Product Change Notice (PCN)

PCN Number: 0454699R-01

Product(s) Affected: *UJ2-BH-1-TH, UJ2-BH-2-TH, UJ2-BH-4-TH, UJ2-BH-W1-TH, UJ2-BH-W2-TH, UJ2-BH-W4-TH, UJ2-BH-BL1-TH*

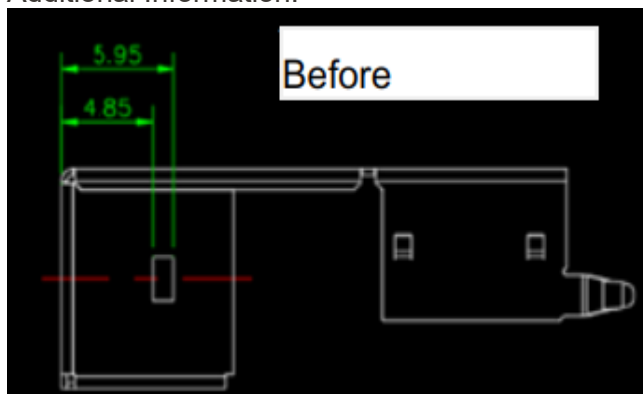
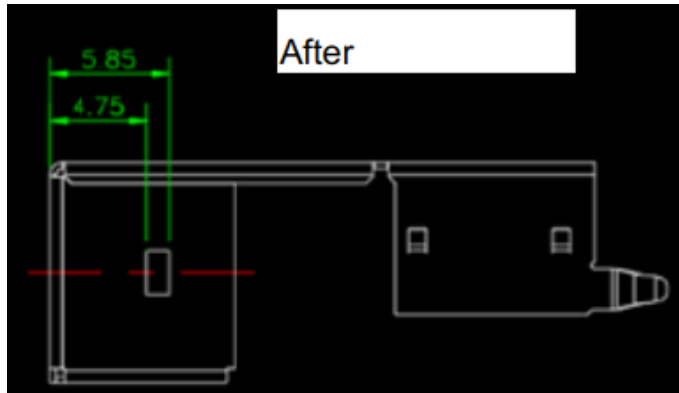
Reason(s) for Change: *Mold Tooling modification for metal shell. Improved mechanical fit.*

Description of Change: *Both plastic housing and metal shell dimensions remain within original product tolerances but contain improvements to enhance structural integrity and achieve tighter fit between plastic housing locking features and the metal shell latch hole. The latch hole has shifted 0.1 mm towards the mating surface. Minimum insertion/pull force has changed from 10 N to 7 N.*
